# A303 - Stonehenge to Berwick Down Scheme

Written Representation of:  
Winterbourne Stoke Parish Council  
Registration ID 20019107  
&  
Dr A D Shuttleworth  
Registration ID 20018263

**Figure 1: Map of Winterbourne Stoke with associated keypoints (blue) and Wiltshire Council byway numbers (red)**

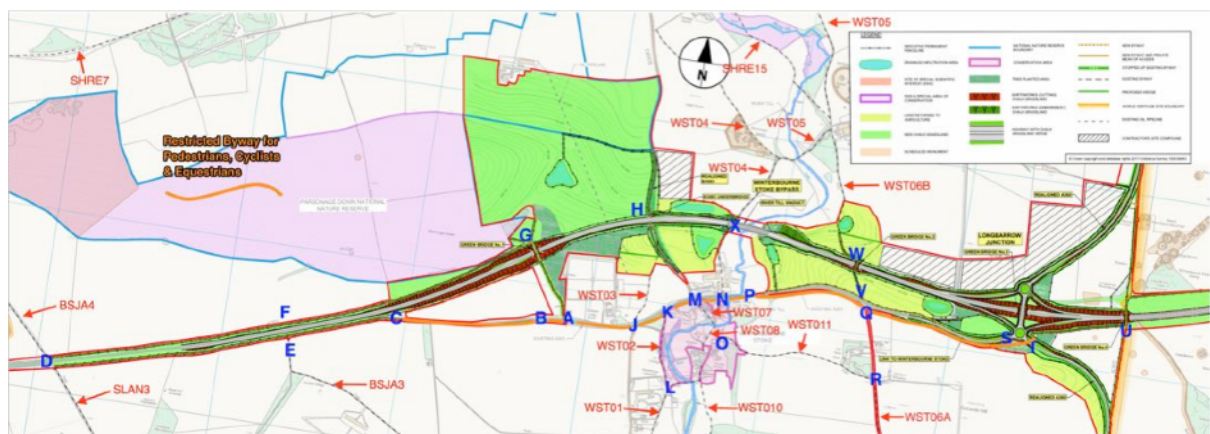
1.10 Given all the above, the western end of the scheme should be moved to the west of the Yarnbury Crossing at point D in Figure 1. To minimise these legitimate safety concerns, an underpass of the A303 should be provided (a bridge would not be appropriate at this point due to the archaeology). Entry/exits onto the A303 from SLAN3 and BSJA4 should be removed for the same reason and the gap in the central reservation could be stopped-up, enhancing traffic safety on the A303.

1.11 A safe crossing at point D is critical in joining byway networks to the north that run towards Wales and to Grovelly Wood and the Kings Way to the south - which connect byway networks westward to Dorset and Devon.

**Figure 4: Map of Winterbourne Stoke with associated key points (blue) and Wiltshire Council byway numbers (red)**

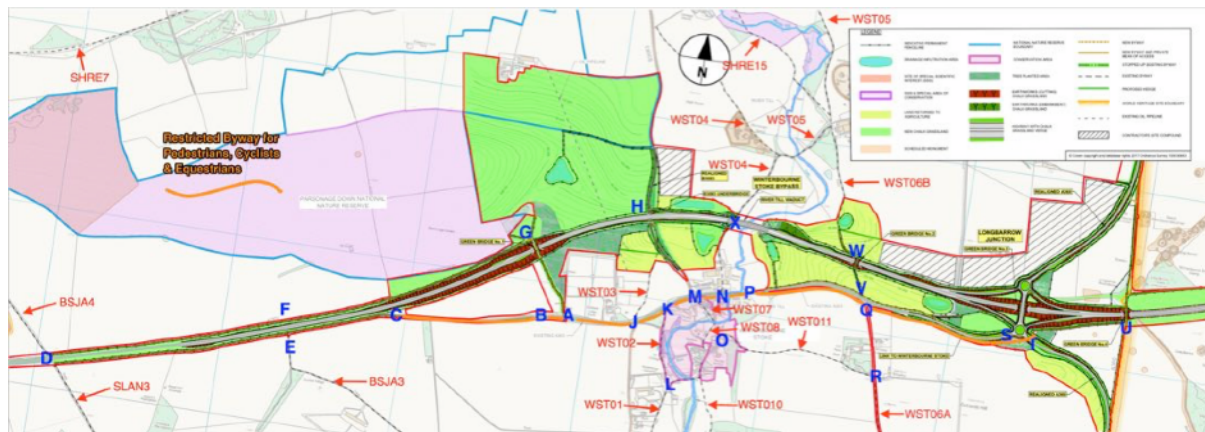
2.17 The needs of agricultural access could be better met by providing an access from the B3083, north of the A303. So, access to fields at G in Fig. 4 above, instead of being via Green Bridge 1 (A-G), should be from the northern side of the B3083, westwards from point H to point G.

**Figure 8: Byway to the west of Winterbourne Stoke**

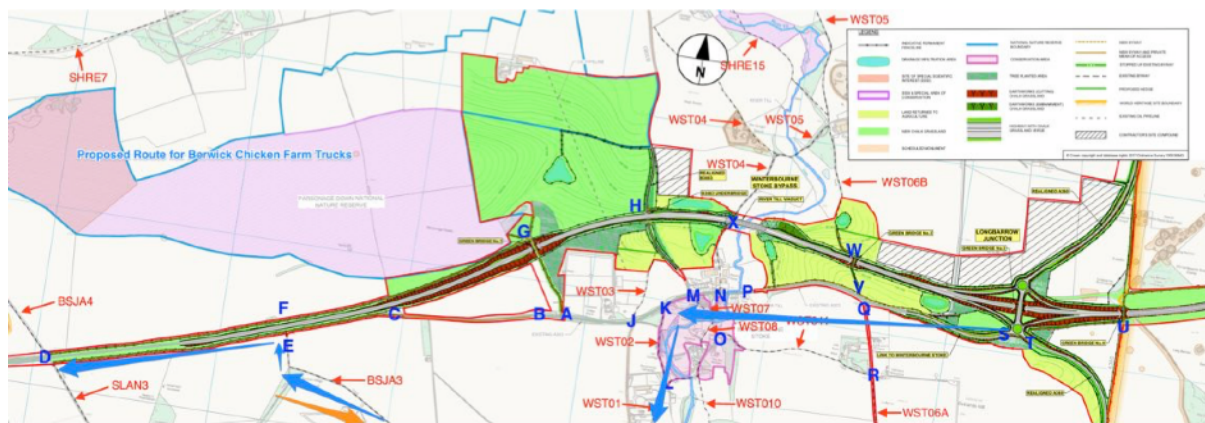
6.1 The entire route (See Fig.8 below from C via AJ-K-M-N-P-Q to S, should be suitable for pedestrians, cyclists and equestrians. From point A eastwards towards S, pedestrians, cyclists and equestrians would, ideally, need to be separated from vehicular traffic. From point P eastwards, the route for pedestrians, cyclists and equestrians should be on the southern side of the current A303, rather than the northern side as proposed by HE. Most of the village lies to the south of the A303 and so placing a pedestrian route on the northern side is simply perverse and illogical when considering likely users and usage.

6.2 The southern side of the existing A303 is preferable, as it already has wider grass verges than the northern side for much of its length. Elsewhere, the southern side consists of rough scrub, hedgerow and land of low farming value. All the land to the north of the A303 on the

6.3 Importantly, there would be no requirement for a crossing of the A303 at point S by the new Longbarrow Roundabout. We regard this as a secondary safety feature to protect pedestrians, cyclists and equestrians from the inevitable high-speed tourists taking the wrong exit from the A360 in their attempts to find the A303 or the Stonehenge Visitor's Centre.
